PIC16C73

PIC16C73 Rev. A Silicon Errata Sheet

The PIC16C73 (Rev. A) parts you have received conform functionally to the Device Data Sheet (DS30390E), except for the anomalies described below.

FIGURE 1: WRITES TO TIMER1 (EXTERNAL CLOCK / OSCILLATOR MODE)

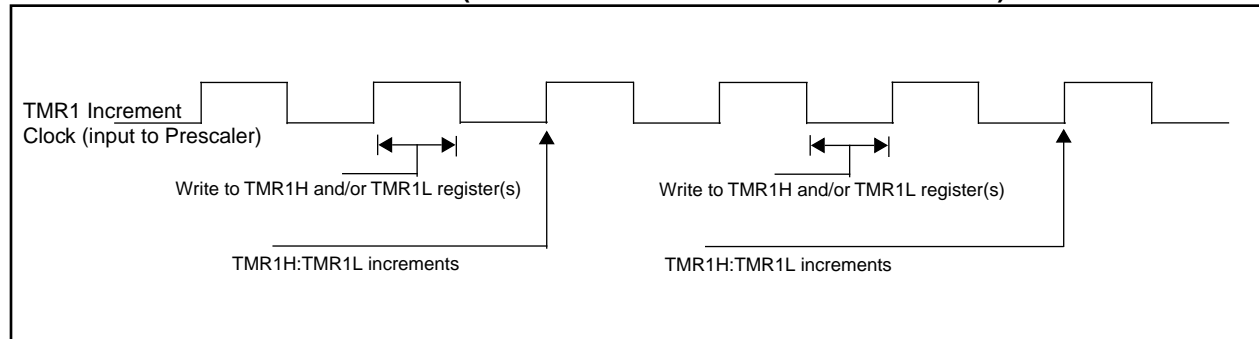
- a) The operation of Timer1 needs some clarification when the timer registers are written when the TMR1ON bit is set.

The internal clock signal that is the input to the TMR1 prescaler affects the incrementing of Timer1 (TMR1H:TMR1L registers and the Timer1 prescaler). When the Timer1 registers are NOT written, the Timer1 will increment on the rising edge of the TMR1 increment clock.

When the TMR1H and/or TMR1L registers are written while this clock is high, TMR1 will increment on the next rising edge of this clock.

When the TMR1H and/or TMR1L registers are written while this clock is low, TMR1 will not increment on the next rising edge of this clock, but must first have a falling clock and the rising clock for TMR1 to increment.

Figure 1 shows the two cases of writes to the TMR1H and/or TMR1L registers. Due to the V_{IH} and V_{IL} thresholds on the oscillator/clock pins, external Timer1 oscillator components, and external clock frequency, the Timer1 increment clock may not be of a 50% duty cycle.

The TMR1 increment clock is out of phase of the T1OSO/T1CKI pin by a small propagation delay.
